Re: **Docket No. 462 – Responses to Development and Management (“D&M”) Plan Interrogatories**

IN RE: :
 :
APPLICATION OF CELCO PARTNERSHIP : DOCKET NO. 462
D/B/A VERIZON WIRELESS FOR A :
CERTIFICATE OF ENVIRONMENTAL :
COMPATIBILITY AND PUBLIC NEED FOR :
THE CONSTRUCTION OF A WIRELESS :
TELECOMMUNICATIONS FACILITY AT 15 :
GREAT PASTURE ROAD, DANBURY, :
CONNECTICUT : AUGUST 24, 2016

**RESPONSES OF CELCO PARTNERSHIP D/B/A VERIZON WIRELESS
TO CONNECTICUT SITING COUNCIL
DEVELOPMENT AND MANAGEMENT PLAN INTERROGATORIES**

1 PARTIAL SITE/SURVEY PLAN
C-1 SCALE: 1"=30'

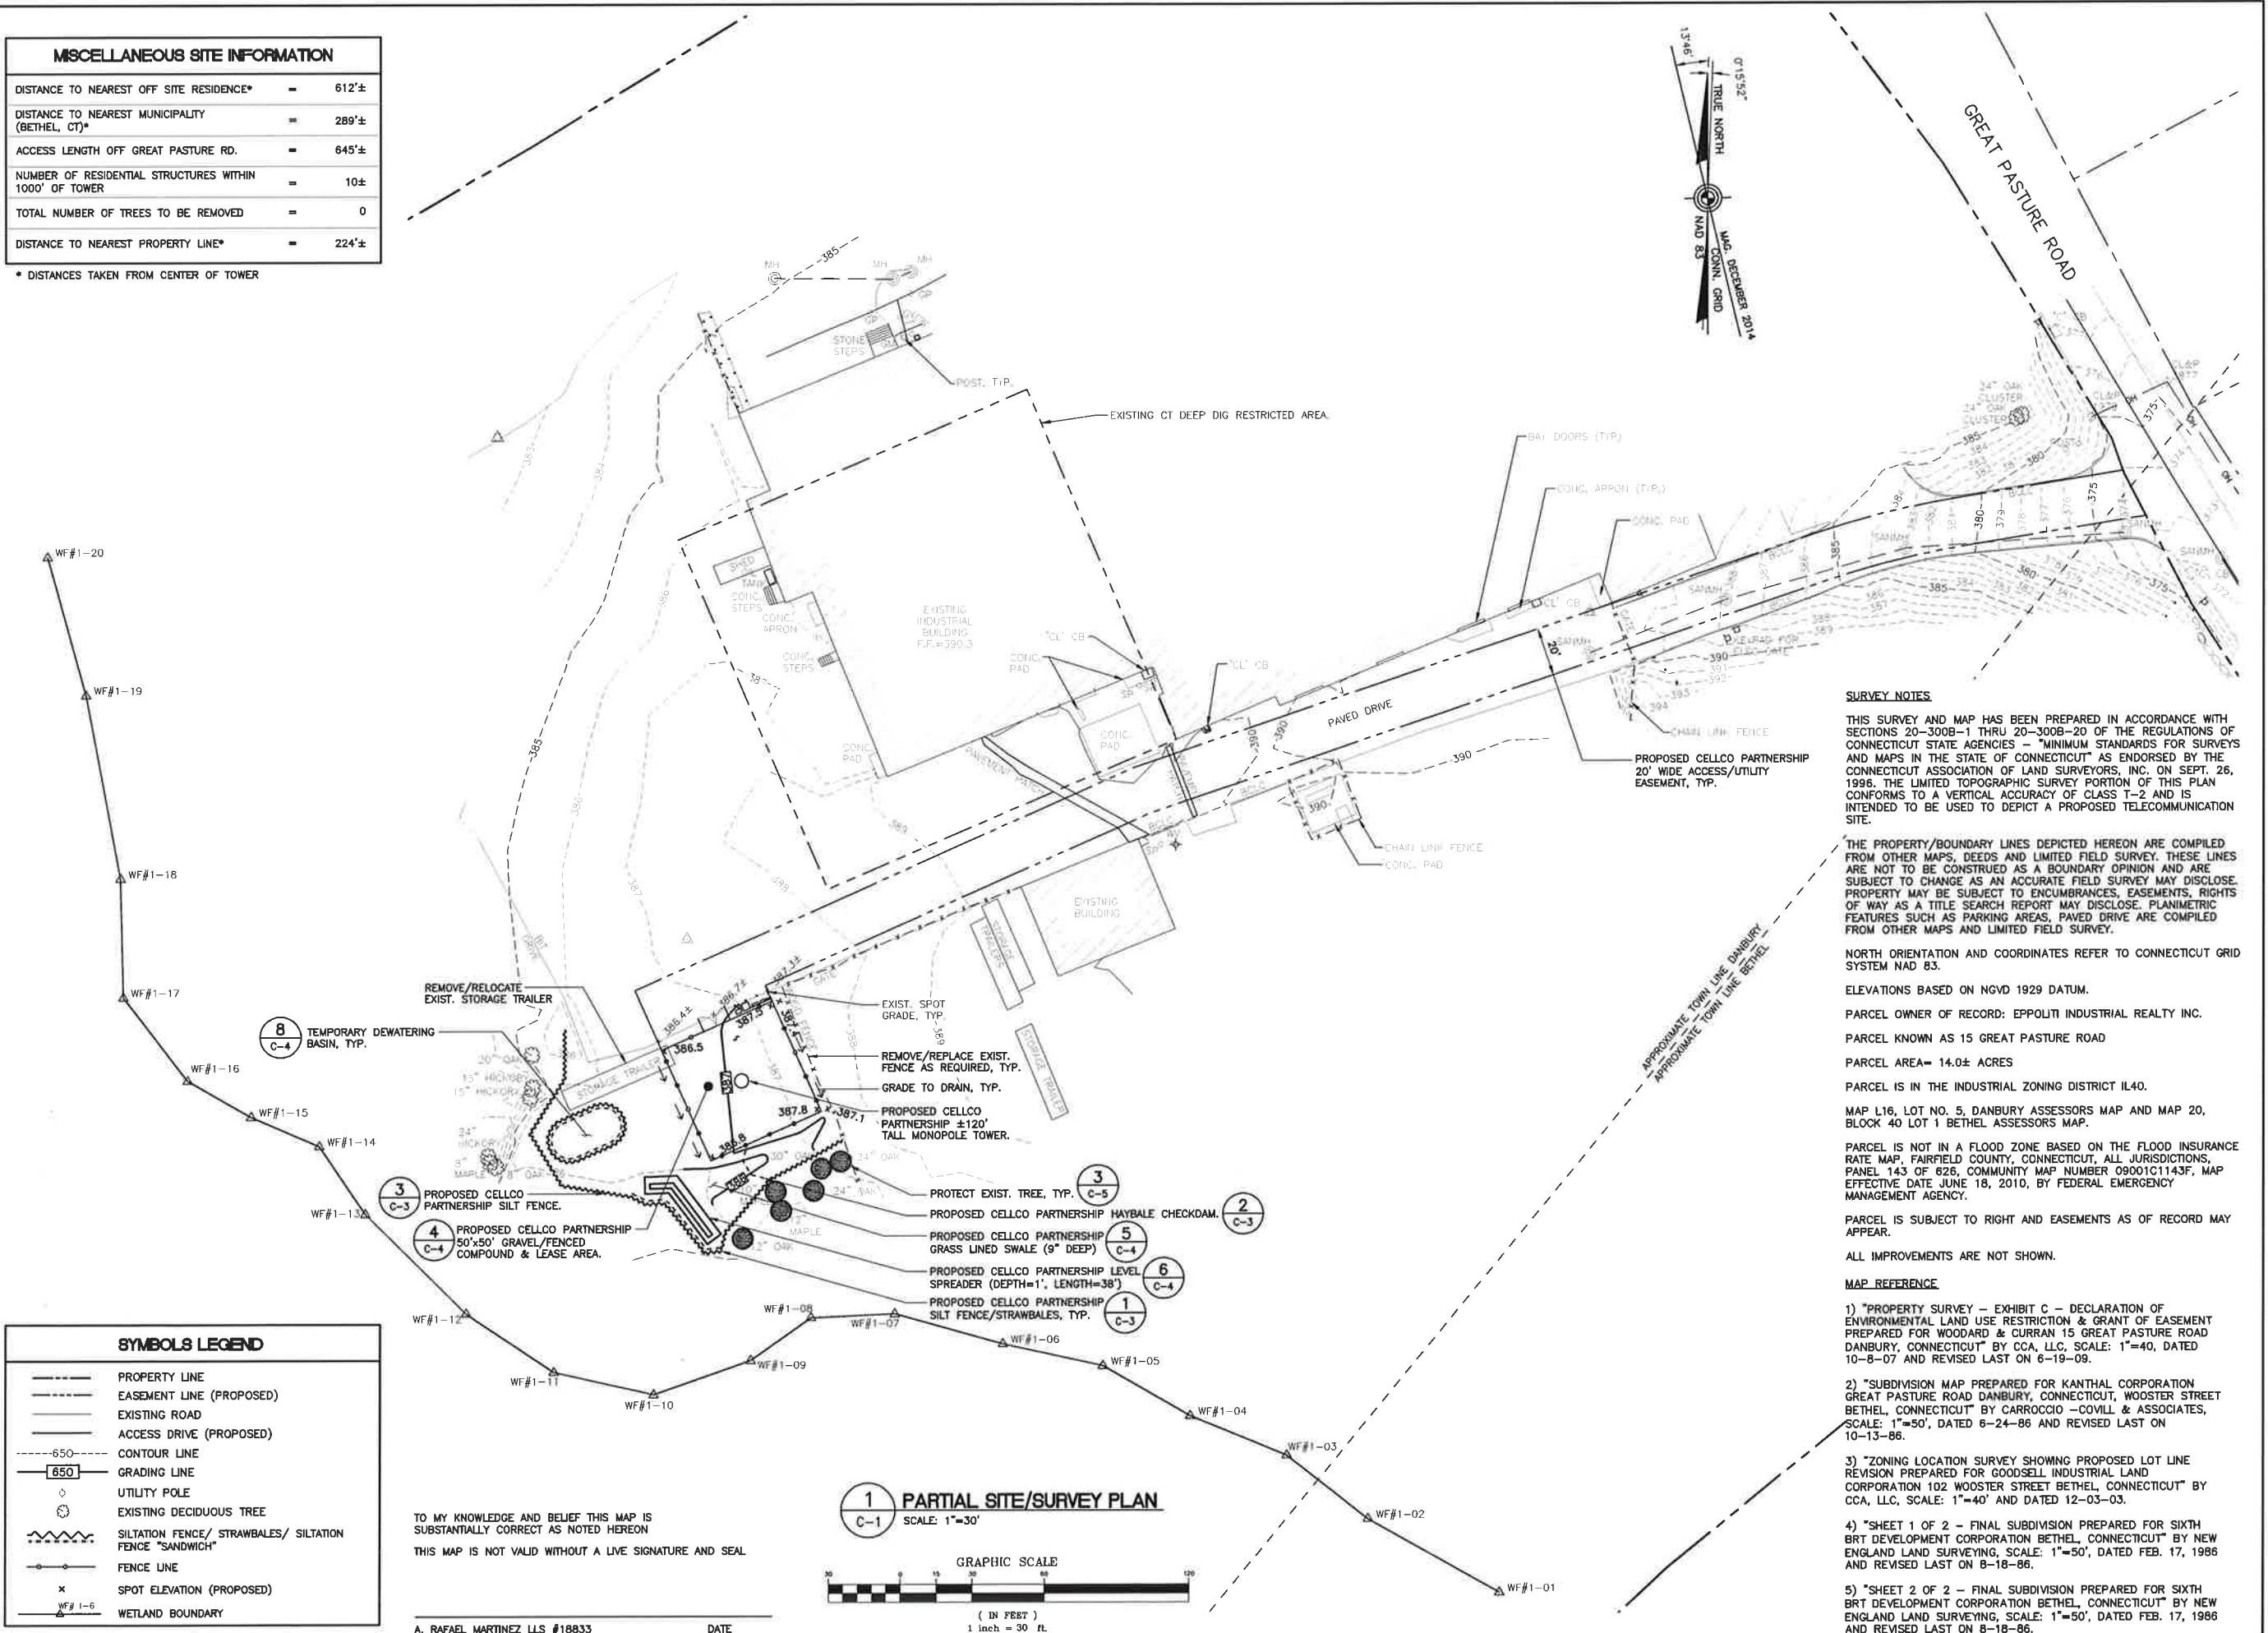
1. An alternative utility conduit route shown on Sheet C-1A, referenced in response to Interrogatory No. 3;
2. A new fence detail on Sheet C-4 showing a 6” to 8” gap at the bottom of the fence as discussed in response to Interrogatory No. 7; and
3. The installation of a new temporary dewatering basin for use during micropile installation per a recent recommendation of Dean Gustafson. In addition, the limits of a siltation fence have been extended to provide space for the dewatering basin. (*See* Sheet C-1).

SITE UTILITY PLAN

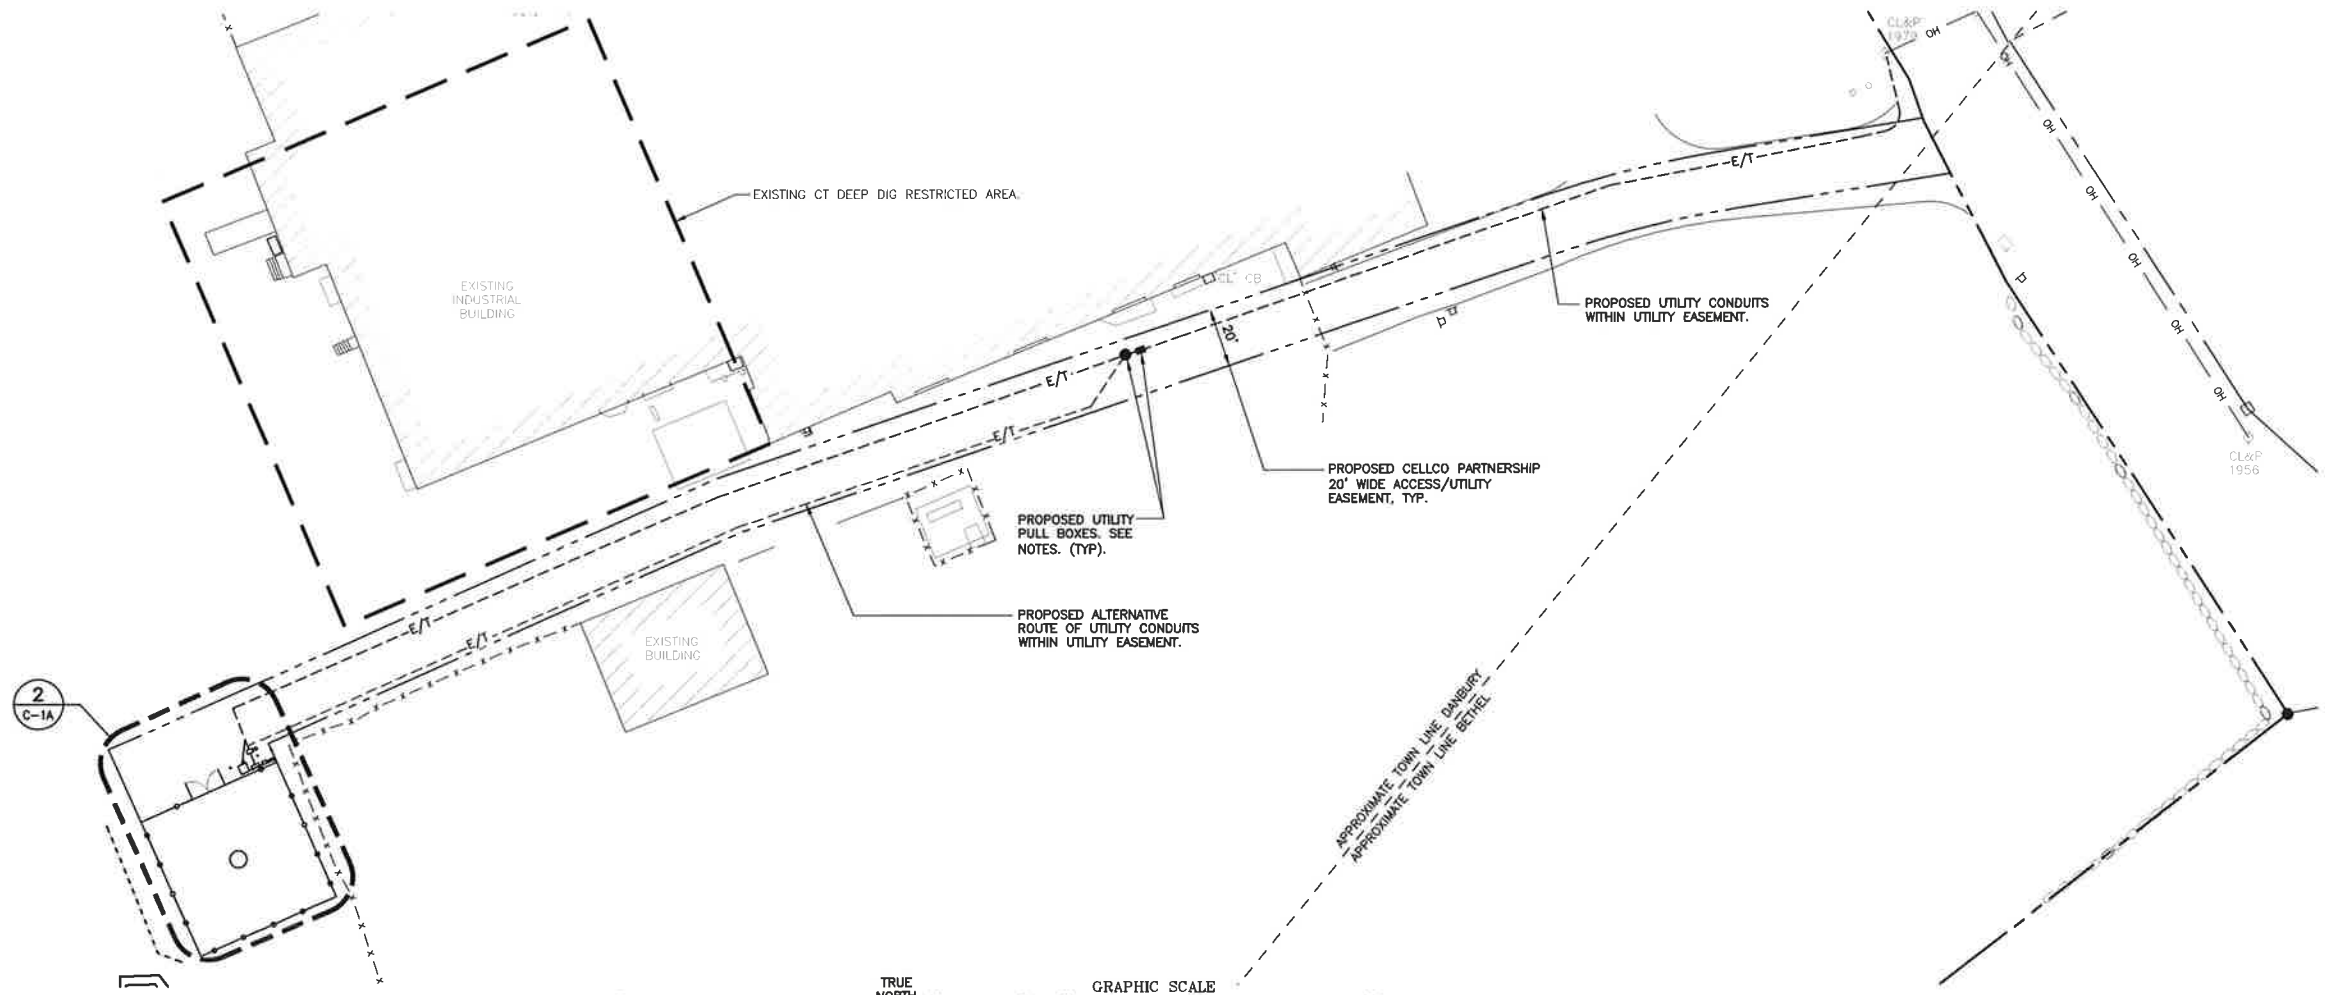
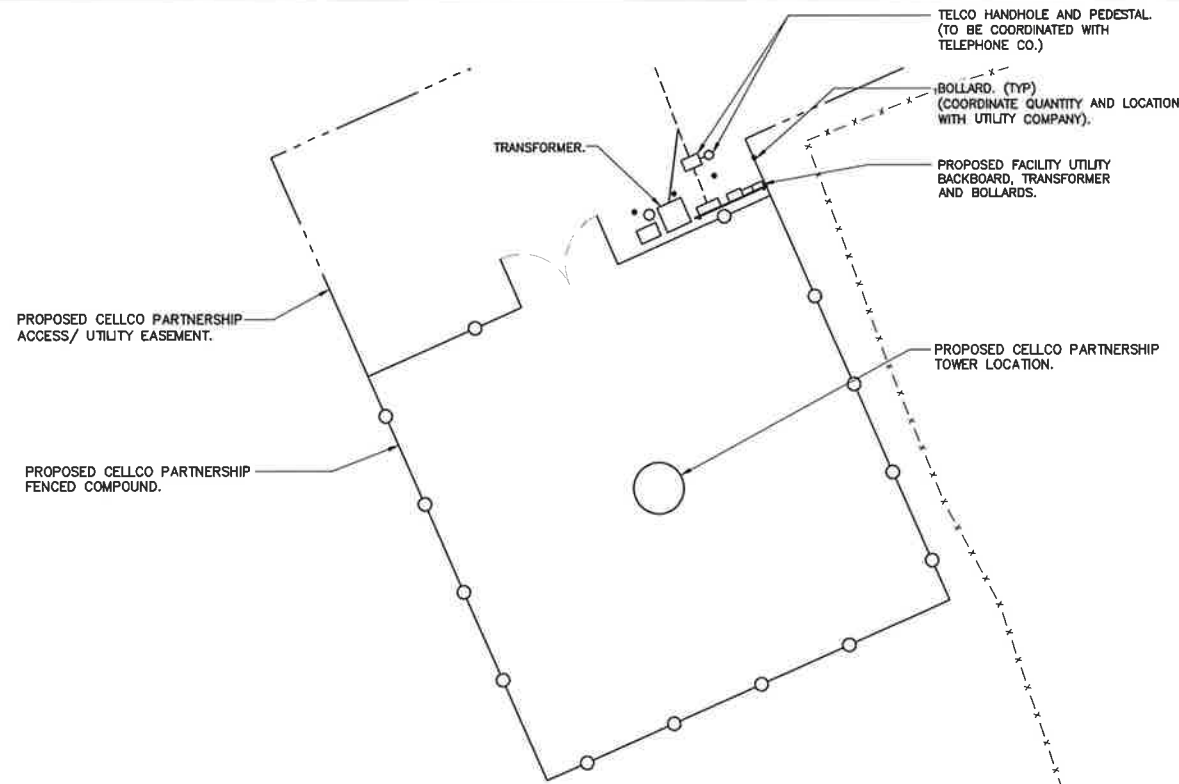
While the proposed underground utilities are not located within the Department of Energy and Environmental Protection's (DEEP) Dig Restricted Area (DRA), provide the maximum depth of the proposed utility trench, and estimate the DRA depth per condition 2a of the Connecticut Siting Council's Decision and Order dated December 10, 2015. Did Cellco Partnership d/b/a Verizon Wireless (Cellco) seek to maximize the horizontal distance from the DRA to the utility trench as well?

Cellco's principle concern for locating the utility trench was simply to stay outside the DRA. The utility trench could be moved further to the south, within the existing easement area and, therefore, further from the DRA, if that would be preferred. (*See* revised D&M Plan – Sheet C-1A showing an alternative utility trench location further from the DRA).

1 WOVEN WIRE FENCE DETAIL
C-4 NOT TO SCALE

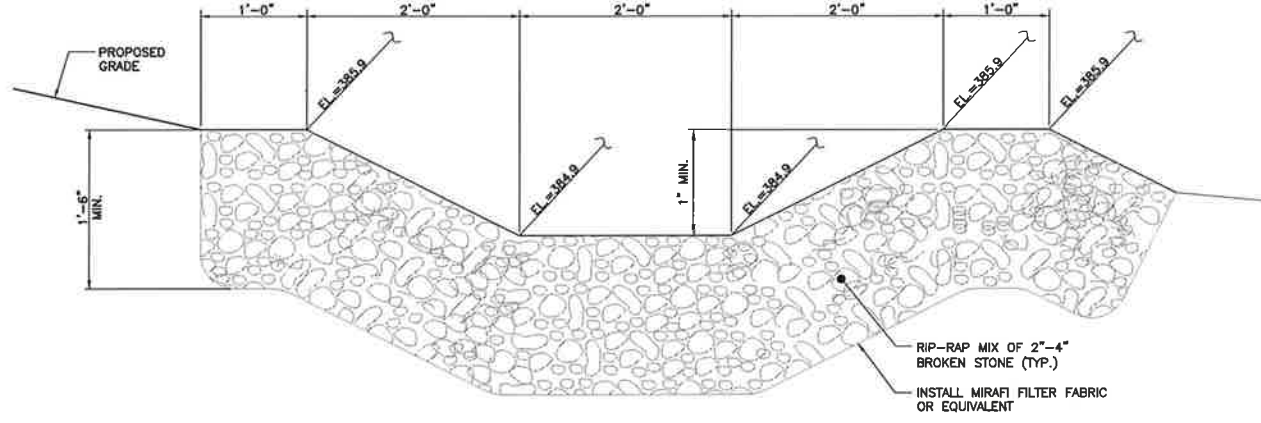
Referencing Sheet C-4 of the D&M Plan, would the proposed 1.5-inch maximum gap under the fence prevent turtle entry and/or reduce risk of entrapment after construction is complete?

Yes, however, Cellco is willing to modify the fence detail and increase the gap at the bottom of the fence to a minimum of 6 to 8 inches to avoid these risks. *See* revised fence detail, D&M Plan Sheet C-4 attached.
